TOWN OF CARMEL
PLANNING BOARD

PLANNING BOARD AGENDA
MAY 11, 2023– 7:00 P.M.

RE: 1035 Rt 6 – Platinum Propane
Town of Carmel
TM# 65.10-2-11

RE: Willow Wood Country Club, Inc.
Amended Site Plan
Union Valley Road
Tax Map No. 87.7-1-6, 7 & 11

C-200

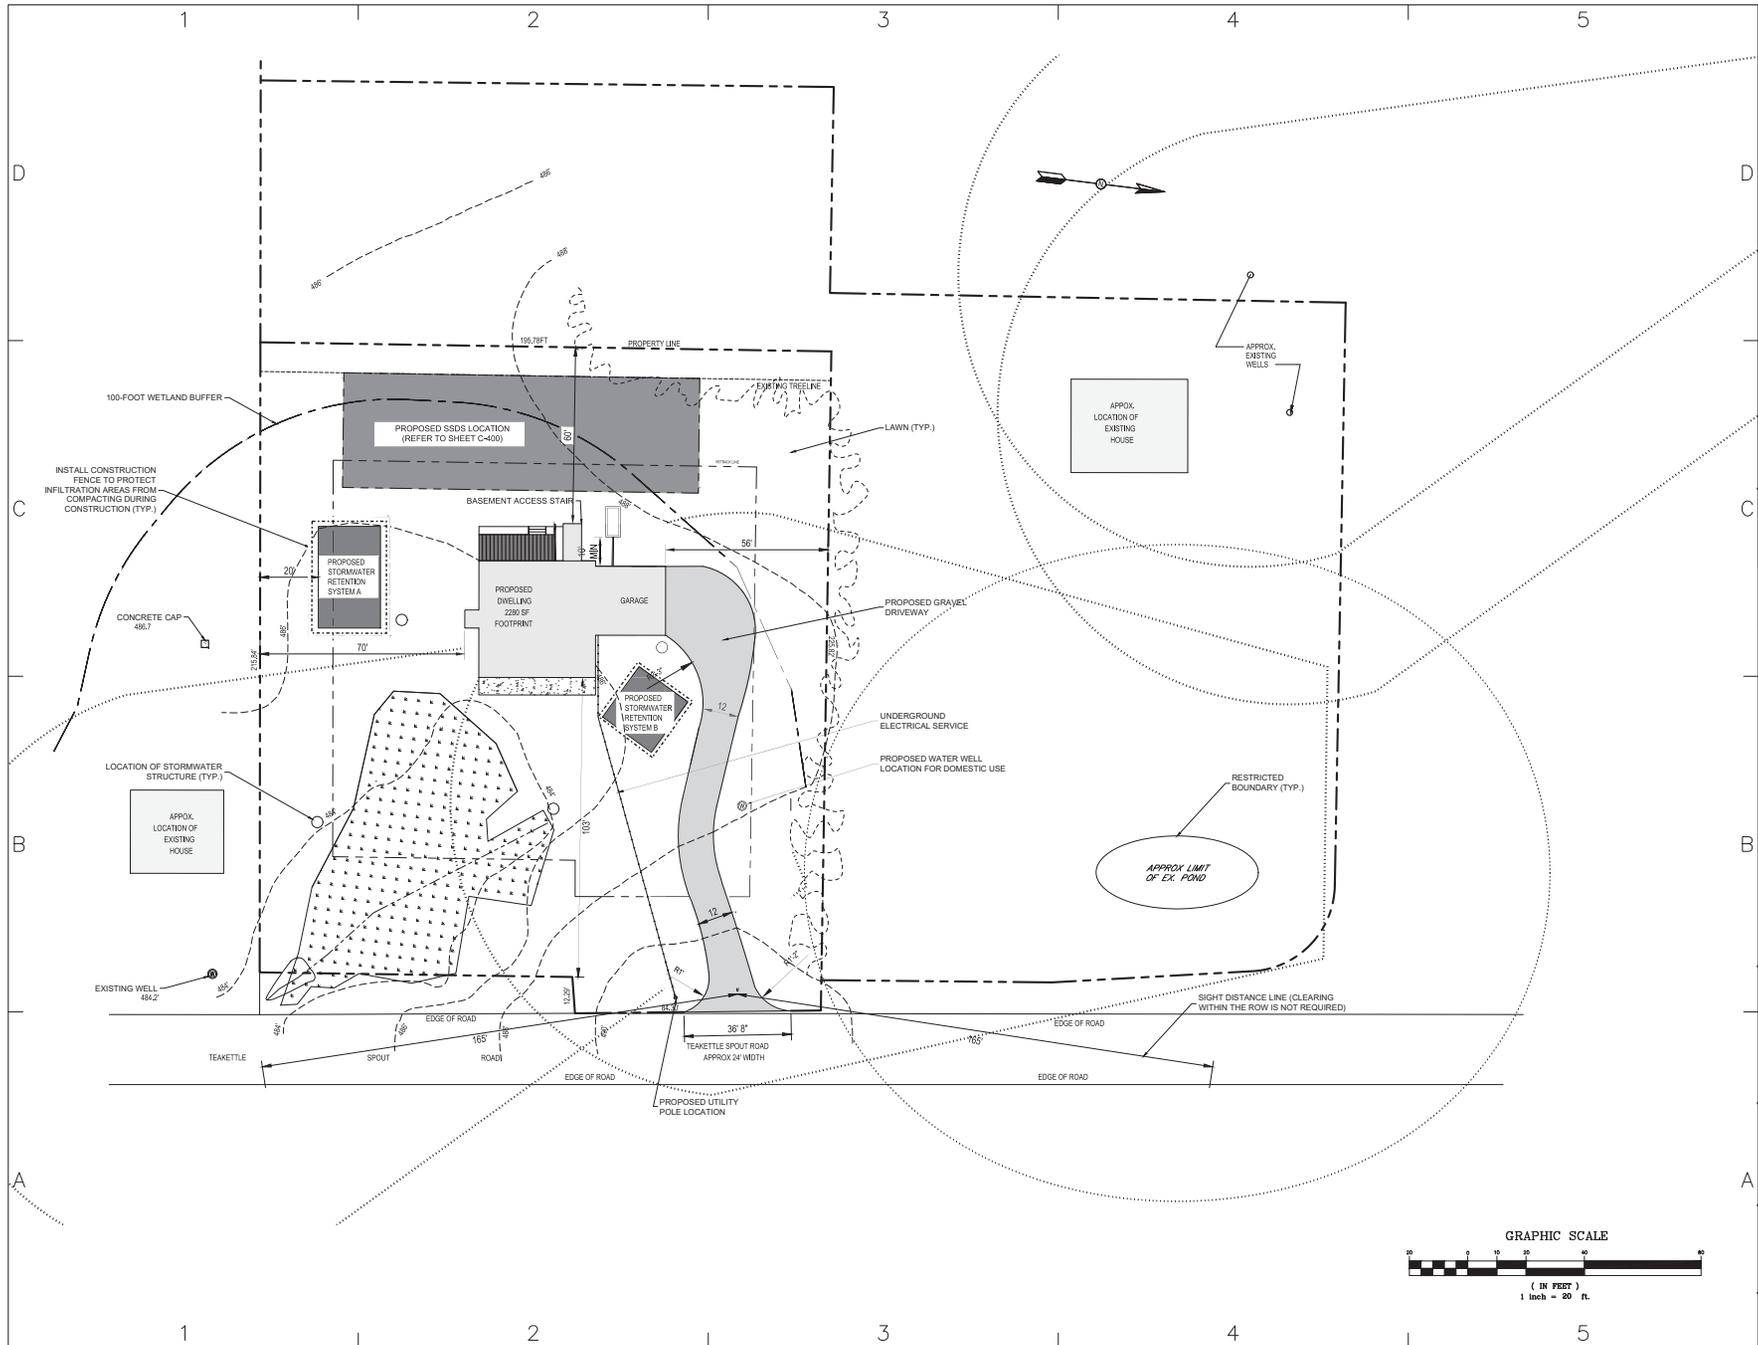
- b. Provide a scale on the drawing ; **scale is shown.**
5. Drawing C-200 -
 - a. The wetland area as identified on Drawing C-100 in the south east portion of the site is identified on this drawing as a center of a dry bed. This should be clarified and corrected on all drawings.

13. Available sight distances at each driveway location should be specified on plan. Any clearing along the edge of the roadway R.O.W. that may be necessary to assure appropriate sight distances are provided, should be identified. **Sight distances are shown on the Sheet C-200 ; clearing a the right-of-way is not required.**

PROJECT NO: ----
CAD DWG FILE: TEAKETTLE 2023 04 28.DWG
DRAWN BY: AL
CHECKED BY: AL
SHEET TITLE: SOIL EROSION AND SEDIMENT CONTROLS
SHEET NUMBER: C-500

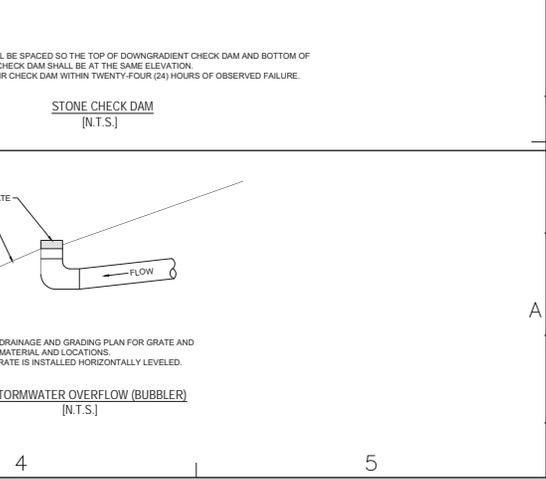
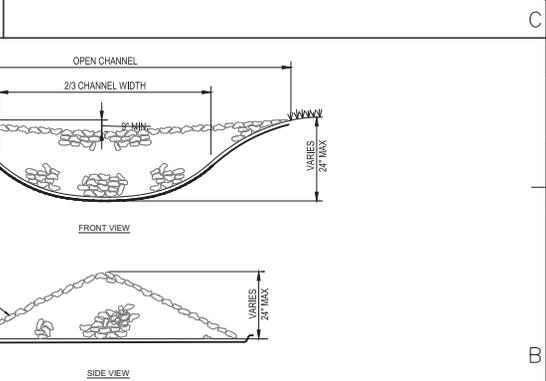
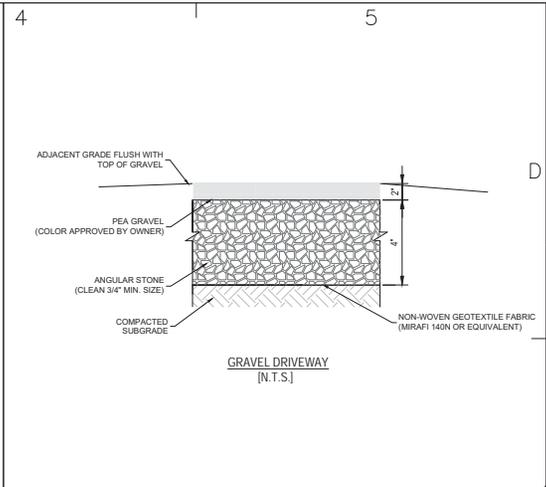
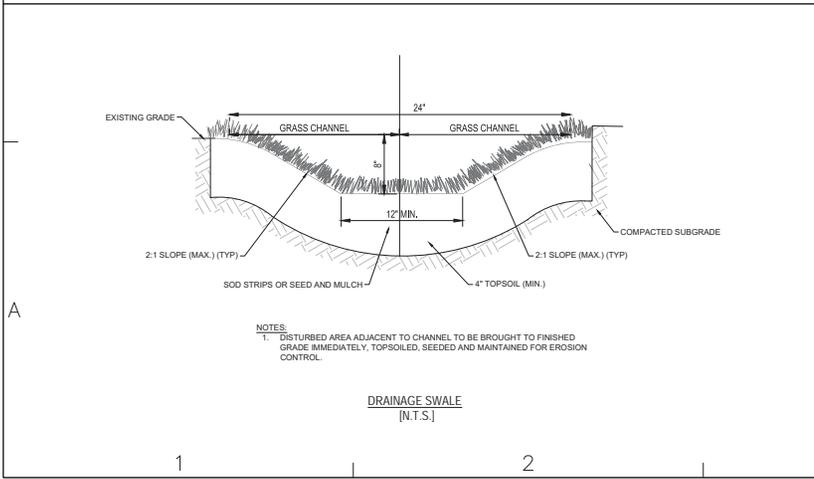
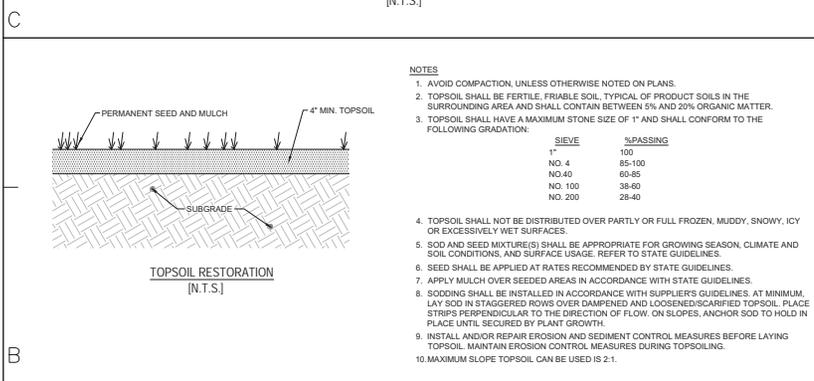
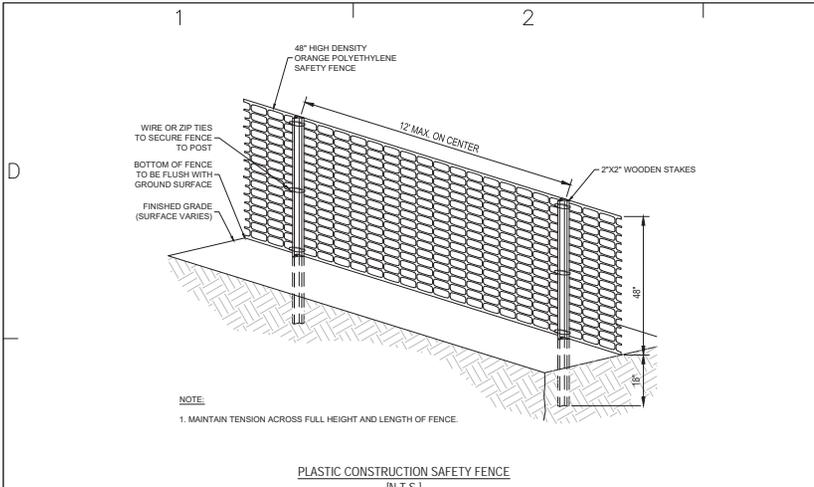
- b. Show silt and construction fencing **These details have been duplicated to show on this sheet also.**
 - c. Construction sequence should be provided in this drawing **Construction Sequence has been added to Sheet C-001 Project Notes and Specifications**

b. The locations of the erosion control blankets and stone check dam should be provided on the drawings **Erosion control blankets have been removed as found not to be required upon further evaluation. The drainage swales to be equipped with stone check dams as a temporary erosion control is shown on Sheet C-500**

DA-100

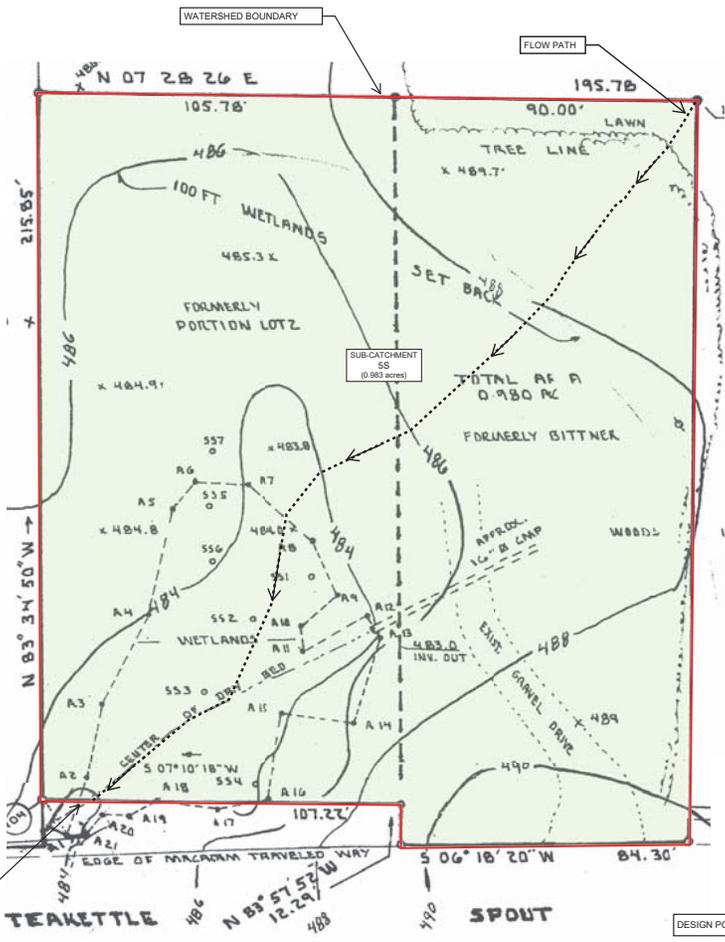
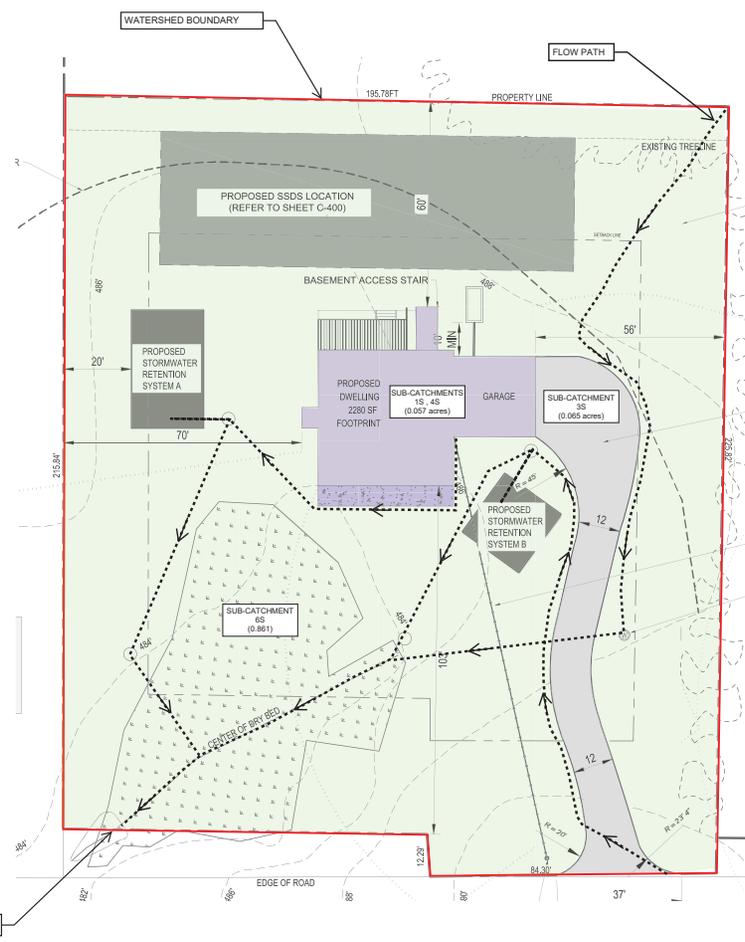
- Drainage areas must be provided/shown on drawings. **Drainage areas have been included on the plans – see Sheet DA-100**
- Location of the proposed swales should be provided. **Swale locations are shown on Sheet C-300 Drainage and Grading Plan.**
